Wall Bracing Examples:

Building #1
One-Story

Steps used to determine wall bracing for Bldg. # 1

Steps used to determine wall bracing for Bldg. # 2

First Floor

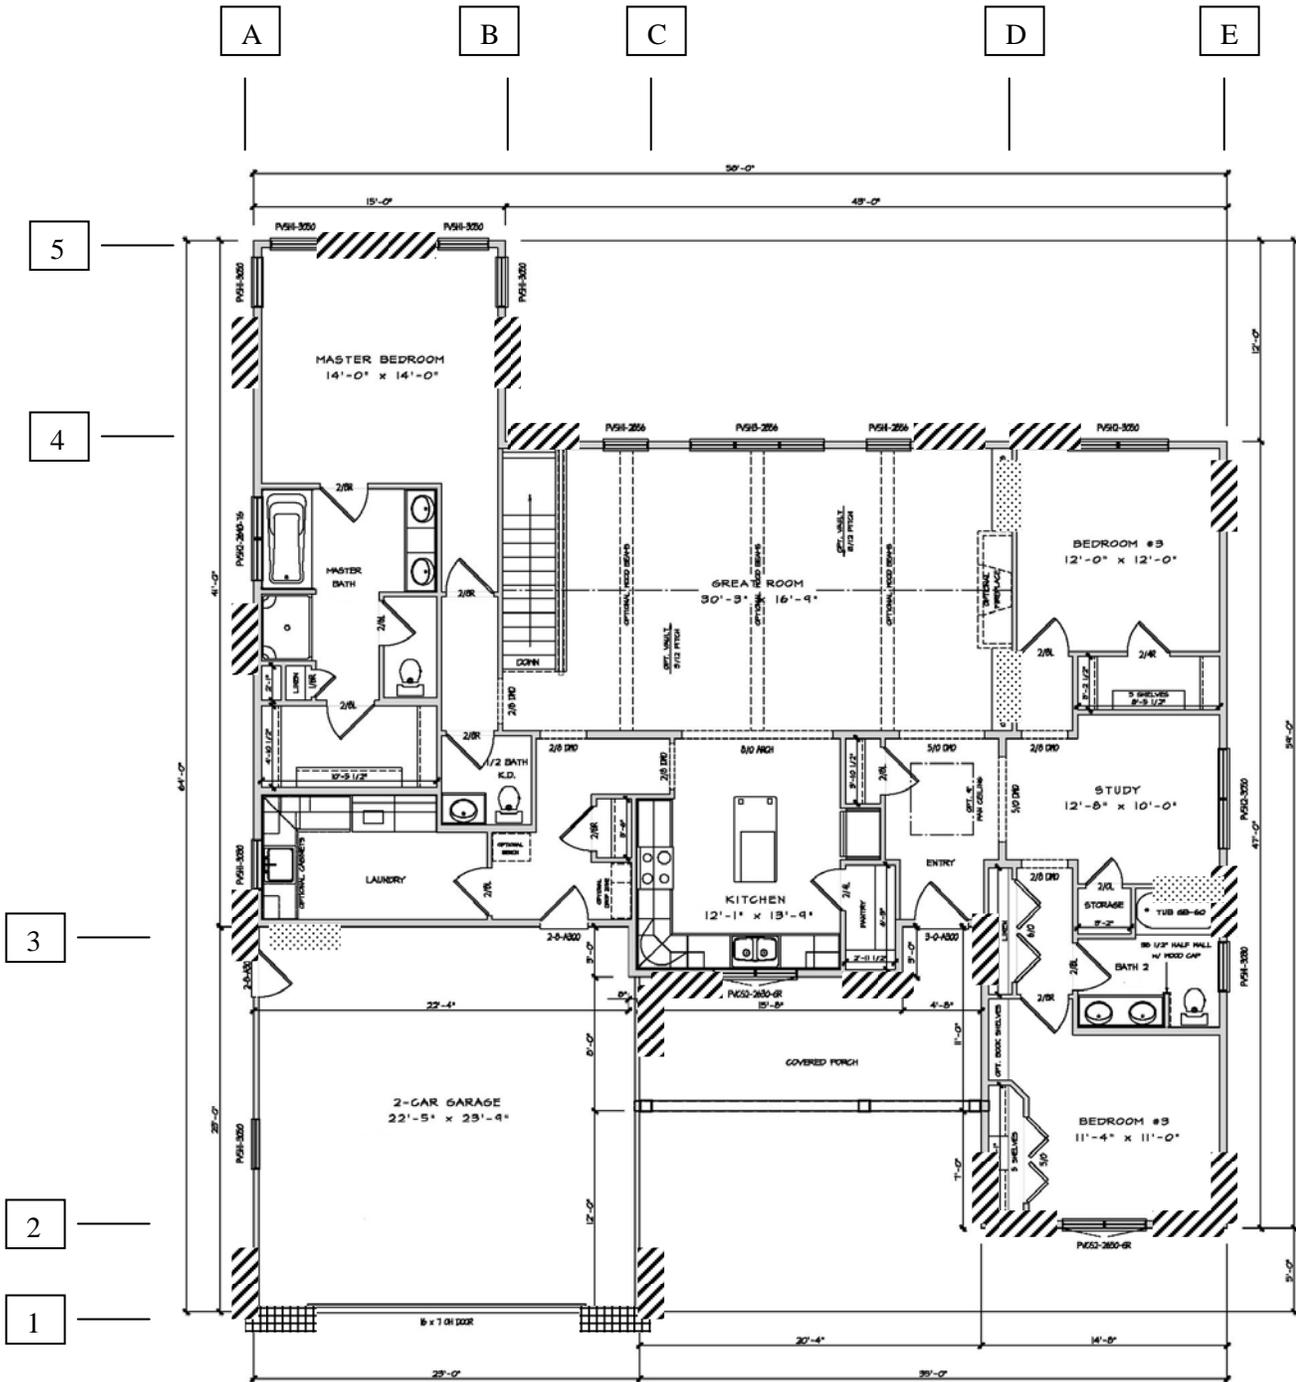
3. Grid Line # 1

- First check to see if you can comply with the wall bracing provisions of Comm 21.25(8) for 4 ft. wide panels or let-in bracing. This wall does not have the 4 ft. wide space available on either side of the garage door.

- An option, as identified on the plan, would be to use the continuously sheathed method of Comm 21.25(9)(c), Fig. 21.25-K with 2 ft. returns.
 - If the garage wall height is 9 ft., this design with the 3" nailing pattern and sheathing overlapping the header permits you to have sheathing on the sides of the garage door opening of 18" minimum. OK

- The percent of braced wall panels provided shall be checked for conformance with Comm 21.25(9)(c)5.c., Table 21.25-H. The length required for this wall line would be $23 \text{ ft.} \times 0.16 = 3.68 \text{ ft.}$ OK.

- Be reminded that the corners at the end of this braced wall line will have to be constructed in accordance with Fig 21.25-G.
- Another option to consider is Comm 21.25(8)(c)2.c., Table 21.25-G. If the wall height of the garage is 9 ft., braced wall panels could be reduced from 48" to 42" in width. If 42" width is provided, then the continuously sheathed method with 3" nailing pattern and 2 ft. returns would not be needed. This would still meet the percentage requirements of Tables 21.25-G and 21.25-H. [$23 \text{ ft.} \times 0.16 = 3.68 \text{ ft.}$ The effective length of 36 inches from Table 21.25-G $\times 2 \text{ sides} = 72" \text{ or } 6 \text{ ft.} > 3.68 \text{ ft.}$ OK]

4. Grid Line # 2 - Provide 4 ft. wide panels or let-in bracing within 12.5 feet of each end.

5. Grid Line # 3 - This grid line contains interior and exterior wall segments that are offset no more than 4 ft. from the braced wall line. Since this is considered one braced wall line, braced wall panels or let-in bracing must only be provided within 12.5 ft. of the ends and spaced no more than 25 ft. on center. As this is no more than 35 ft. from grid line #1 and grid line #4 this satisfies the maximum 35 ft. braced wall line spacing requirements. Note: Grid line # 4 was used for this spacing determination instead of grid line #5 as it is that exterior wall that has the majority of the braced wall panels to resist the wind loads.

6. Grid Line # 4 - Provide 4 ft. wide panels or let-in bracing within 12.5 ft. of each end and a maximum of 25 ft. on-center.

7. Grid Line # 5 - Provide 4 ft. wide panels or let-in bracing within 12.5 feet of each end. The plan shows two of 4 ft. wide panels. The code may be met by using just one panel in the center of the braced wall line as this would be within 12.5 ft. of each end. The single panel would also meet the percentage requirements of Table 21.25-H. [$15 \text{ ft.} \times 0.16 = 2.4 \text{ ft.} < 4 \text{ ft.}$ provided.]

- Provide 4 ft. wide panels within 12.5 ft. of each end and a maximum of 25 ft. on-center.
- Note: The plans show that let-in/diagonal bracing can be used in this braced wall line. After further review and consideration it has been determined that let-in bracing can not be used because this is a braced wall line that exceeds the 35 ft. braced wall line spacing requirement (grid lines A and D) resulting in a need for a check of an added amount of wall bracing required by Comm 21.25(8)(c)2. The use of grid lines B and C could not be considered in that spacing check above, as they do not extend to within 12.5 ft. of each endwall.
- Determine percent wall bracing required. Since the distance between braced walls lines A and D is 46 feet the required percentage would be $(46 \text{ ft.}/35 \text{ ft.} \times 0.16) \times 64 \text{ ft.}$ wall length = 13.5 ft. < 16 ft. provided. OK.

9. Grid Line B - Provide a 4 ft. wide panel within 12.5 ft. of each end.

10. Grid Line C - Provide 4 ft. wide panels within 12.5 ft. of each end. A single panel centered in the braced wall line would meet this requirement. Note, though, that a 2 ft. return may be required at the overhead garage door and the 4 ft. panel at the end would serve a dual purpose.

- This grid line contains interior and exterior wall segments that are offset no more than 4 ft. from the braced wall line. Since this is considered one braced wall line, braced wall panels or let-in bracing must only be provided within 12.5 ft. of the ends and spaced no more than 25 ft. on center.

- Note: The plans show that let-in/diagonal bracing can be used in this braced wall line. After further review and consideration it has been determined that let-in bracing can not be used because this is a braced wall line exceeding 35 ft. braced wall line spacing requirement (grid lines A and D) resulting in a check of an added amount of wall bracing required by Comm 21.25(8)(c)2.

- Determine percent wall bracing required. Since the distance between braced walls lines A and D is 46 feet the required percentage would be $(46 \text{ ft.}/35 \text{ ft.} \times 0.16) \times 47 \text{ ft.}$ wall length = 9.9 ft. < 16 ft. provided. OK.

12. Grid Line E - Provide 4 ft. wide panels or let-in bracing within 12.5 feet of each end and a maximum of 25 ft. on-center.

First Floor

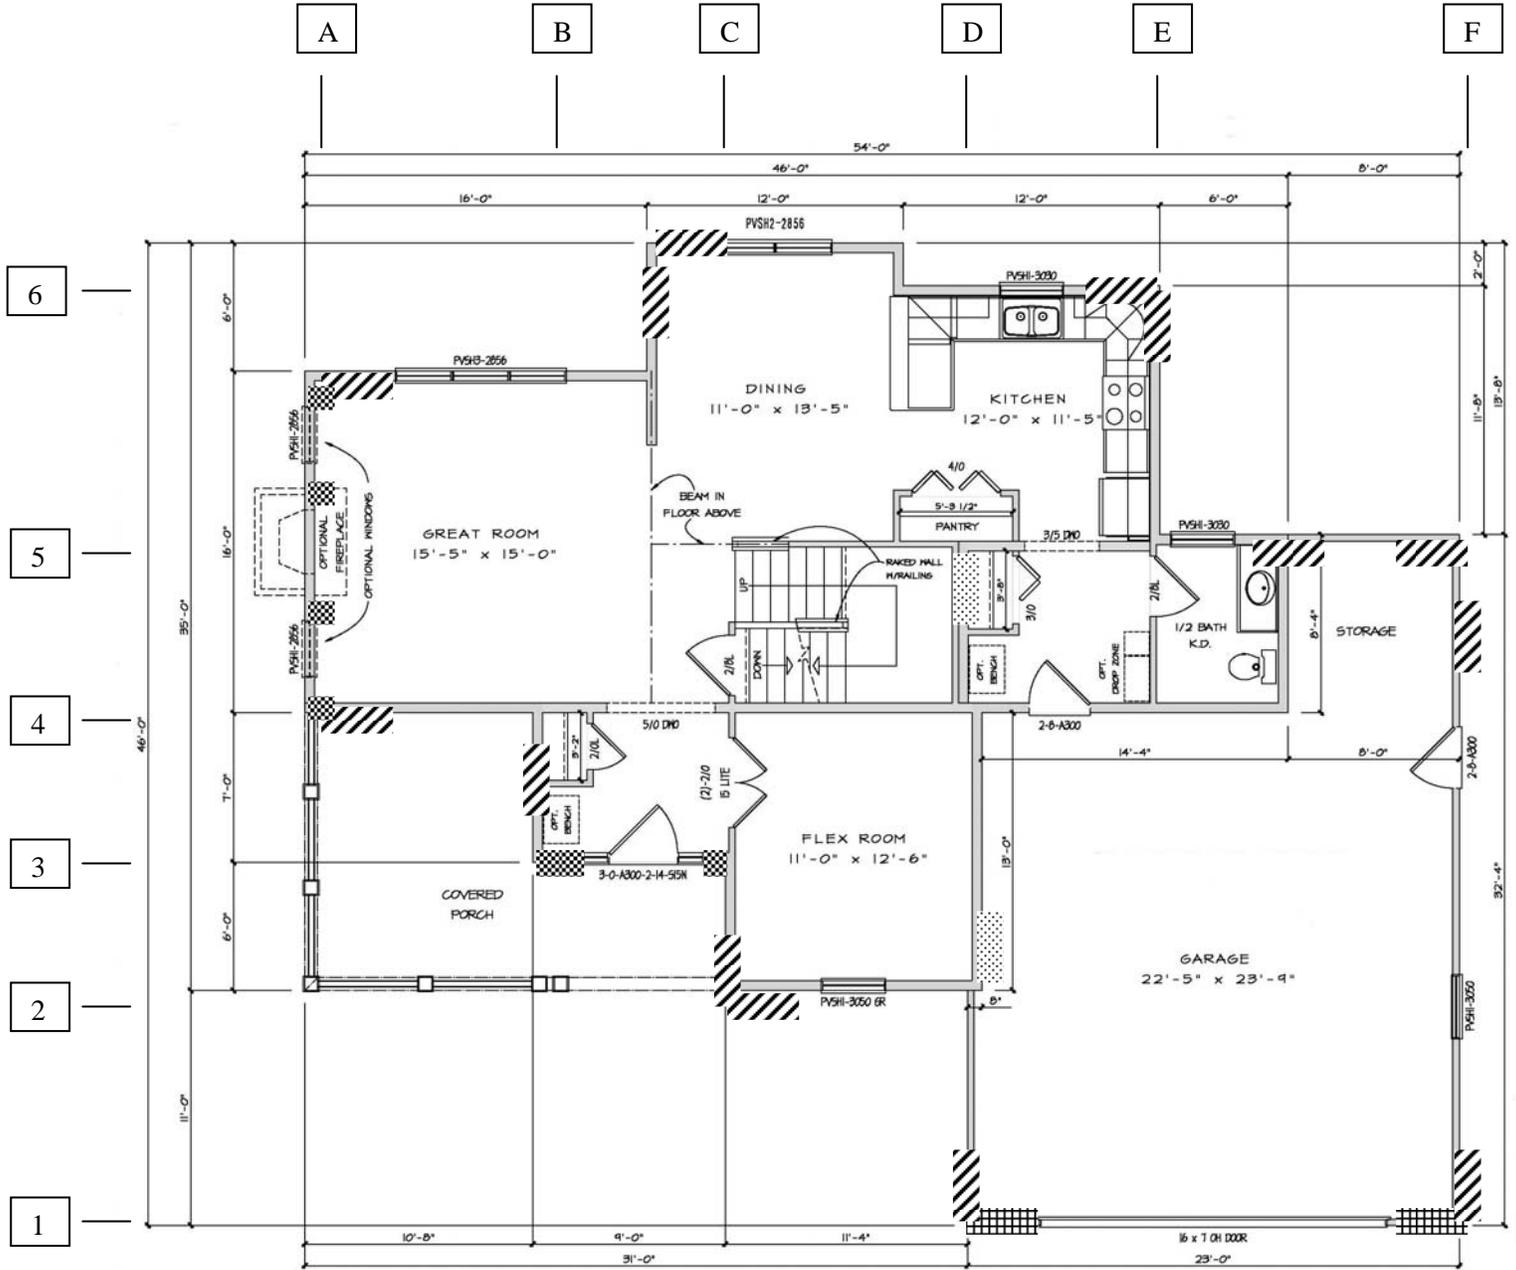
3. Grid Line # 1

- First check to see if you can comply with the wall bracing provisions of Comm 21.25(8) for 4 ft. wide panels or let-in bracing. This wall does not have the 4 ft. wide space available on either side of the garage door.

- An option, as identified on the plan, would be to use the continuously sheathed method of Comm 21.29(9)(c), Fig. 21.25-K with 2 ft. returns.
 - If the garage wall height is 9 ft., this design with the 3" nailing pattern and sheathing overlapping the header permits you to have sheathing on the sides of the garage door opening of 18" minimum. OK

- The percent of braced wall panels provided shall be checked for conformance with Comm 21.25(9)(c)5.c., Table 21.25-H. The length required for this wall line would be $23 \text{ ft.} \times 0.16 = 3.68 \text{ ft.}$ OK.

- Be reminded that the corners at the end of this braced wall line will have to be constructed in accordance with Fig 21.25-G.
- Another option to consider is Comm 21.25(8)(c)2.c., Table 21.25-G. If the wall height of the garage is 9 ft., braced wall panels could be reduced from 48" to 42" in width. If 42" width is provided, then the continuously sheathed method with 3" nailing pattern and 2 ft. returns would not be needed. This would still meet the percentage requirements of Tables 21.25-G and 21.25-H. [$23 \text{ ft.} \times 0.16 = 3.68 \text{ ft.}$ The effective length from Table 21.25-G of 36 in. $\times 2 \text{ sides} = 72" \text{ or } 6 \text{ ft.} > 3.68 \text{ ft.}$ OK]

4. Grid Line # 2 - Provide a 4 ft. wide panel or let-in bracing within 12.5 feet of each end.

- This wall does not have the 4 ft. wide space available on either side of the entrance door. The continuously sheathed method, as identified on the plan, will need to be used. In accordance with Table 21.25-J, the braced wall segments at the ends of this braced wall line will have to be at least 32 inches

wide and have return at the ends of at least 2 ft. [note not shown]. In addition the corners will have to be constructed in accordance with Fig. 21.25-G.

- An option, if the builder can not meet the 32” minimum braced wall panel length requirement, would be to use the continuously sheathed method of Comm 21.29(9)(c), Fig. 21.25-K with 2 ft. returns [not on shown on diagram]. The additional nailing and overlapping of sheathing over a header would permit a braced wall panel width of 16” in an 8 ft. high wall.

6. Grid Line # 4 - Provide a 4 ft. wide panel or let-in bracing within 12.5 ft. of each end.

7. Grid Line # 5 – Provide 4 ft. wide panels or let-in bracing within 12.5 ft. of each end and a maximum of 25 ft. on-center. The plan shows two of 4 ft. wide panels. The code may be met by using just one panel in the center of the braced wall line as this would be within 12.5 ft. of each end. The single panel would also meet the percentage requirements of Table 21.25-H. [$14 \text{ ft.} \times 0.16 = 2.24 \text{ ft.} < 4 \text{ ft.}$ provided.]

- This grid line contains exterior wall segments that are offset no more that 4 ft. from the braced wall line. Since this is considered one braced wall line, braced wall panels or let-in bracing must only be provided within 12.5 ft. of the ends and spaced no more than 25 ft. on center.
- Determine percent wall bracing required per Table 21.25-H.: $40 \text{ ft. wall length} \times 0.16 = 6.4 \text{ ft.} < 12 \text{ ft.}$ provided. OK.

9. Grid Line A [– Plan notes options, inspector should verify which is chosen as below:]

- This wall does not have the 4 ft. wide space available between the fireplace and the windows, if all were provided in this braced wall line. The continuously sheathed method was identified as an option on the plan. In accordance with Table 21.25-J, this would mean that the braced wall segments at the ends of this braced wall line will have to be at least 24 in. wide if the wall is 8 ft. in height and the windows do not take up more than 67% of the wall height.

- If this width can not be met, the fireplace will have to go if the windows are provided and, if the fireplace is provided, the windows must go. Also, if the fireplace or windows are not provided there may be enough space in the braced wall line to get a 4 ft. braced wall panel in and thus eliminating the 2 ft. returns, and specially constructed corners per Fig. 21.25-G.

- Another option may be use Comm 21.25(9)(c)5., Fig. 21.25-K with 2 ft. returns.

10. Grid Line B - Provide a 4 ft. wide panel or let-in bracing within 12.5 ft. of each end.

11. Grid Line C - Provide 4 ft. wide panels within 12.5 ft. of each end. Note that as there is a 3’-8” difference in wall line of dining room and wall line of the flex room walls as designed, this can qualify as one wall line. With large openings in the center of this braced wall line, it would not likely to meet the 25 ft. spacing requirement, causing some additional analysis as shown in following for grid D.

- This grid line contains interior and exterior wall segments that are offset no more than 4 ft. from the braced wall line. As kitchen is only 11'-5" wide, this braced wall line meets the 12.5 ft. from kitchen exterior wall to interior braced wall gypsum sheathing between closet & stairs. Since this is considered one braced wall line, braced wall panels or let-in bracing must only be provided within 12.5 ft. of the ends and spaced no more than 25 ft. on center.
- Note: The plans show that let-in/diagonal bracing can be used in this braced wall line. After further review and consideration it has been determined that let-in bracing could be used because this is a braced wall line that does not exceed the 35 ft. braced wall line spacing requirement, since the distance between braced walls lines A and D is 31 feet. OK.

13. Grid Line E - Provide a 4 ft. wide panel or let-in bracing within 12.5 ft. of each end.

14. Grid Line F - Provide 4 ft. wide panels or let-in bracing within 12.5 feet of each end and a maximum of 25 ft. on-center.

Second Floor

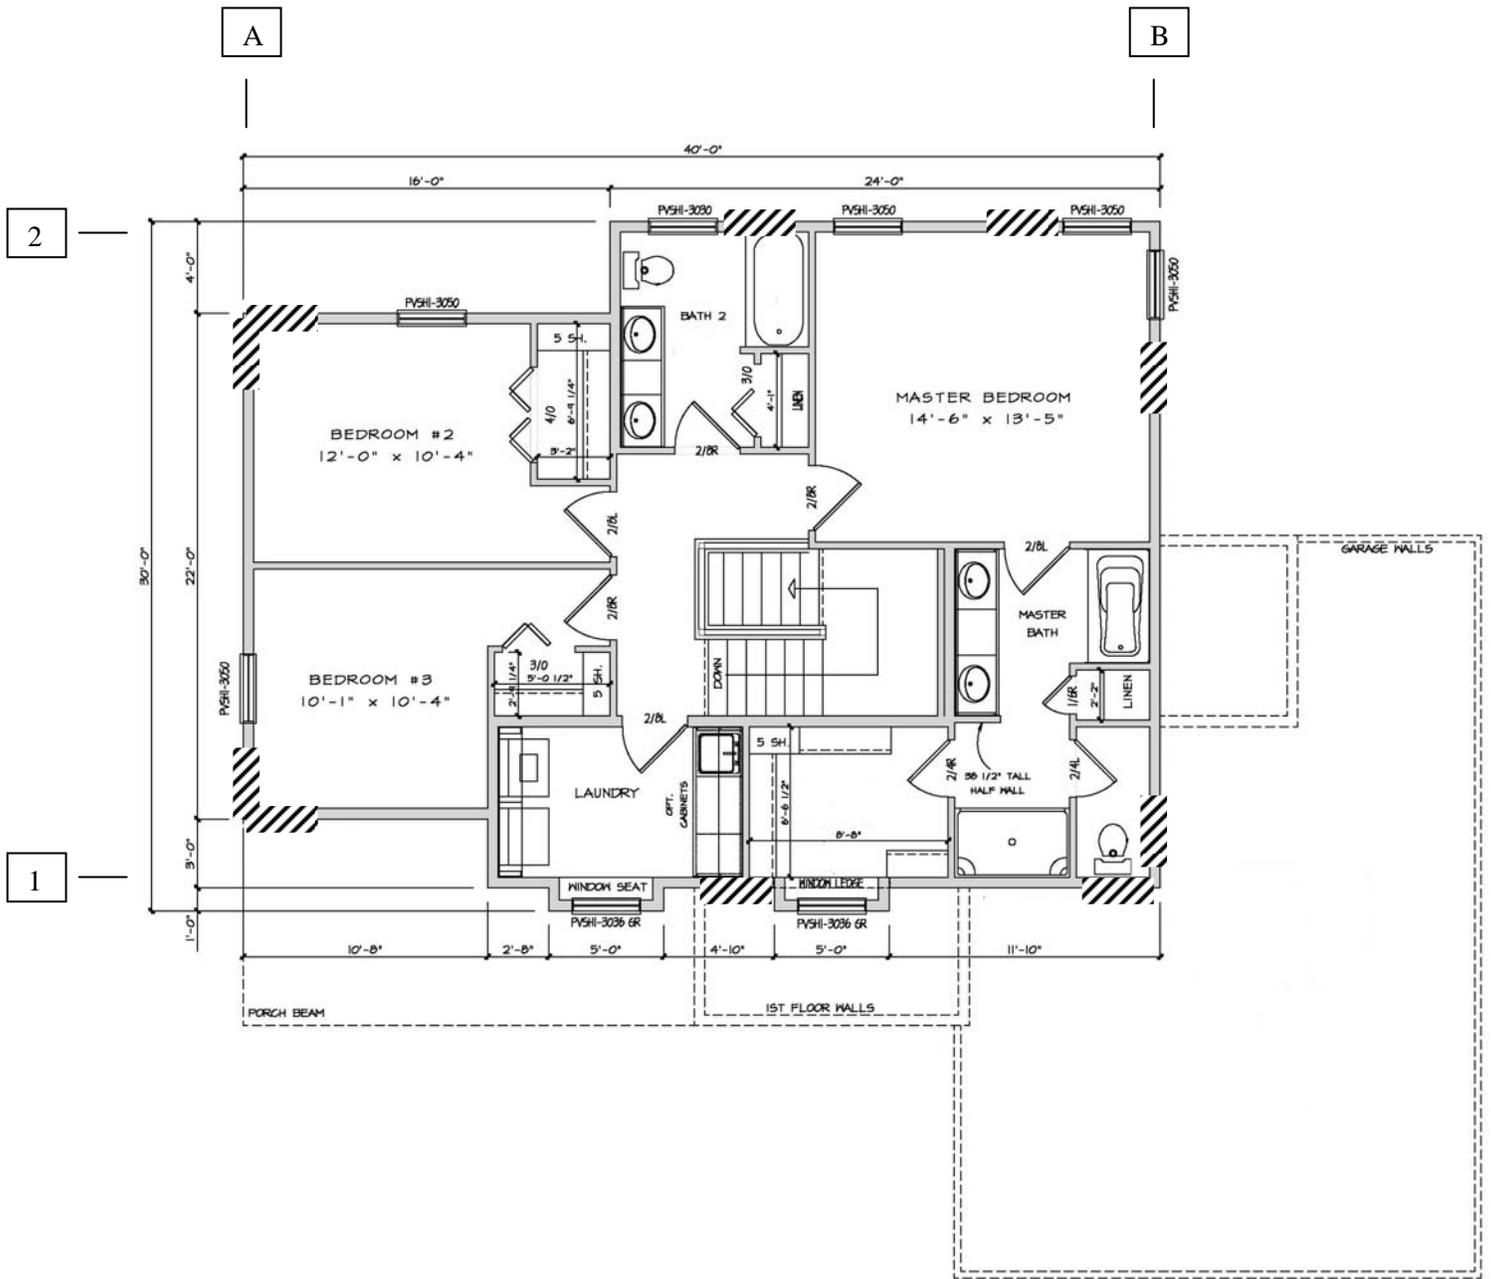
1. Grid Line # 1

- This grid line contains exterior wall segments that are offset no more than 4 ft. from the braced wall line. Since this is considered one braced wall line, braced wall panels or let-in bracing must only be provided within 12.5 ft. of the ends and spaced no more than 25 ft. on center.
- Determine percent wall bracing required per Table 21.25-H.: wall length 40 ft. $X 0.16 = 6.4 \text{ ft.} < 12 \text{ ft.}$ provided. OK.

2. Grid Line # 2

- This grid line contains exterior wall segments that are offset no more than 4 ft. from the braced wall line. Since this is considered one braced wall line, braced wall panels or let-in bracing must only be provided within 12.5 ft. of the ends and spaced no more than 25 ft. on center.
- Determine percent wall bracing required per Table 21.25-H.: 40 ft. wall length $X 0.16 = 6.4 \text{ ft.} < 12 \text{ ft.}$ provided. OK.

3. Grid Line A

- Provide 4 ft. wide panels within 12.5 feet of each end and a maximum of 25 ft. on-center.
- Note: The plans show that let-in/diagonal bracing can be used in this braced wall line. After further review and consideration it has been determined that let-in bracing can not be used because this is a braced wall line that exceeds the 35 ft. braced wall line spacing requirement (grid lines A and B) resulting in a need for a check of an added amount of wall bracing required by Comm 21.25(8)(c)2.
- Determine percent wall bracing required. Since the distance between braced walls lines A and B is 40 feet the required percentage would be $(40 \text{ ft.}/35 \text{ ft.} X 0.16) X 22 \text{ ft. wall length} = 4.0 \text{ ft.} < 8 \text{ ft.}$ provided. OK.

4. Grid Line B

- Provide 4 ft. wide panels within 12.5 feet of each end and a maximum of 25 ft. on-center.
- Note: The plans show that let-in/diagonal bracing can be used in this braced wall line. After further review and consideration it has been determined that let-in bracing can not be used because this is a braced wall line that exceeds the 35 ft. braced wall line spacing requirement (grid lines A and B) resulting in a need for a check of an added amount of wall bracing required by Comm 21.25(8)(c)2.
- Determine percent wall bracing required. Since the distance between braced walls lines A and B is 40 feet the required percentage would be $(40 \text{ ft.}/35 \text{ ft.} X 0.16) X 30 \text{ ft. wall length} = 5.5 \text{ ft.} < 8 \text{ ft.}$ provided. OK.
